SOUTH TEXAS PROJECT ELECTRIC GENERATING STATION

SPECIFICATION
 FOR
 ALTERNATE VALVE PACKING AND LIVE LOAD DESIGN
 HOUSTON LIGHTING & POWER CO.

SPECIFICATION NO. 5L749TS1018

SOUTH TEXAS PROJECT ELECTRIC GENERATING STATION
PCF AMENDMENT FORM

FIGURE 2

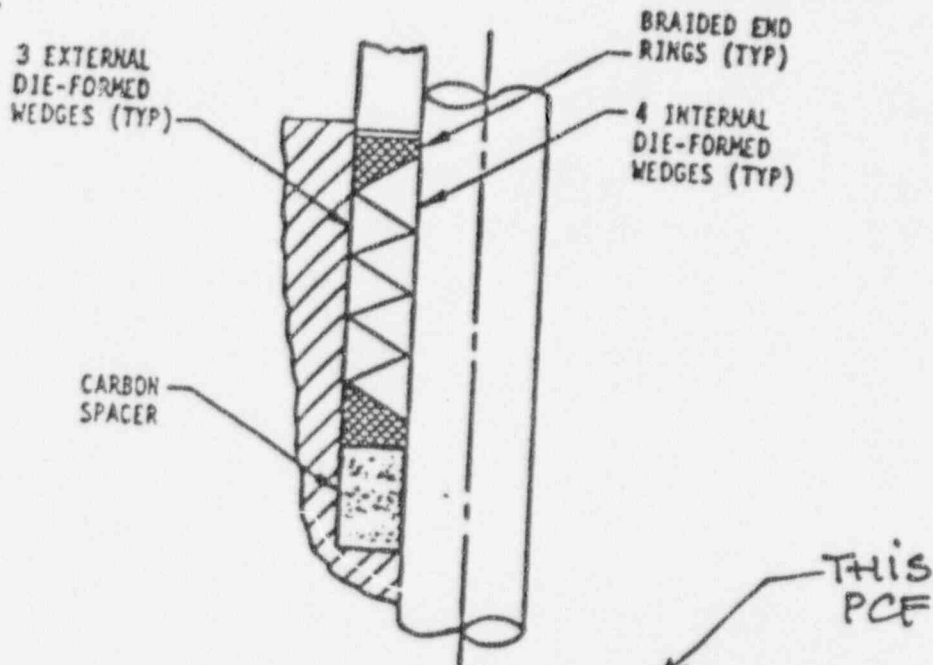
Revise Section 5.1 and Figure 2 of specification no. 5L749TS1018 as shown on the attached pages to allow the use of Chesterton Style 5800 wedge type packing set.

CHESTERTON STYLE 5800 WEDGE may be used as an alternate packing set for the EPRI wedge packing set, CHESTERTON STYLE 5350. STYLE 5800 WEDGE is a five-ring graphite packing set which consists of two die-formed end rings, two inside diameter sealing rings and one outside diameter sealing ring.

A. Chesterton Style 5350 OR CHESTERTON STYLE 5800 WEDGE

FIGURE 7

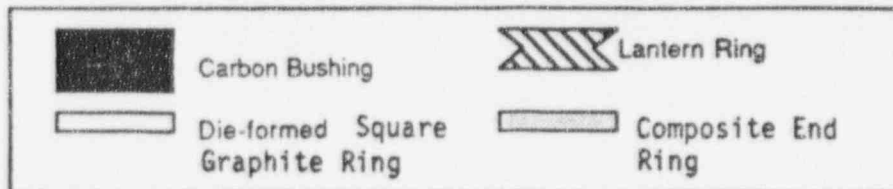
REVISE PAGES 3, 5, 6 AND 7 & ADD FIGURE 7.
SEE ATTACHED FOR DETAILS.

4.2.4 Alternate packing configurations using flexible graphite / amorphous carbon composite end rings shall be in accordance with configurations A through F of the Figure 7 .

Valves with operable leak-off connections and lantern rings shall be repacked with one of the illustrations shown in Figure 4 and Figure 7 (configurations G through M). The packing arrangement using composite end rings in Figure 7 is preferred.

INSERT H: (add attached Figure 7 to the specification)
